SUBJECT: Forwards info responding to questions re QA program & provides program update reflecting QA responsibility for preliminary testing. Info will be incorporated in Nov 1984 FSAR amend.

October 25, 1984
(NMP2L 0217)

Re: Nine Mile Point Unit 2
Docket No. 50-410

Figure 17.1-2

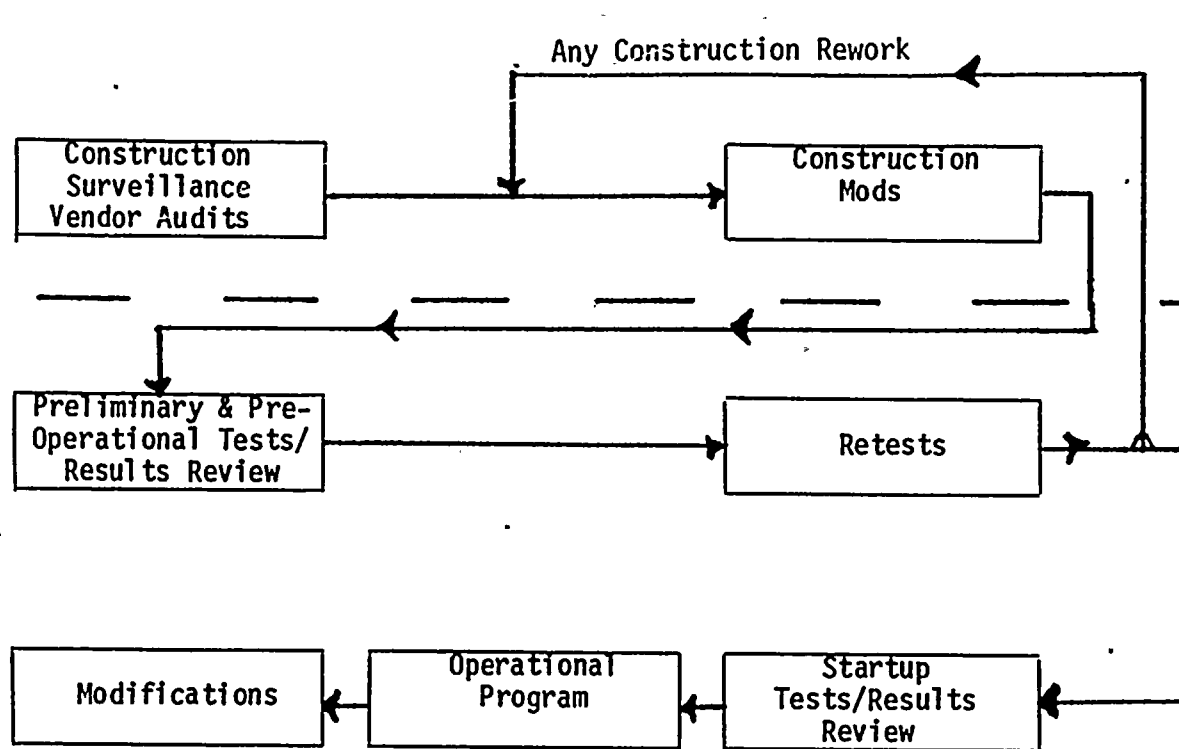
Enclosed for your use is information which responds to Nuclear Regulatory Commission staff questions on the Nine Mile Point Unit 2 Quality Assurance program and provides a program update to reflect Quality Assurance responsibility for preliminary testing. This information will be incorporated in the November 1984 Final Safety Analysis Report Amendment.

Additionally, we will provide an update to Chapter 14 in the November 1984 Final Safety Analysis Report Amendment to reflect the change in performance of preliminary testing, specifically the fact that Niagara Mohawk will be managing this effort.

APPLICABLE QA PROGRAM AND ORGANIZATION
USED DURING PRELIMINARY TESTING/CON-
STRUCTION, PREOPERATIONAL TESTING AND
STARTUP TESTING/OPERATIONS
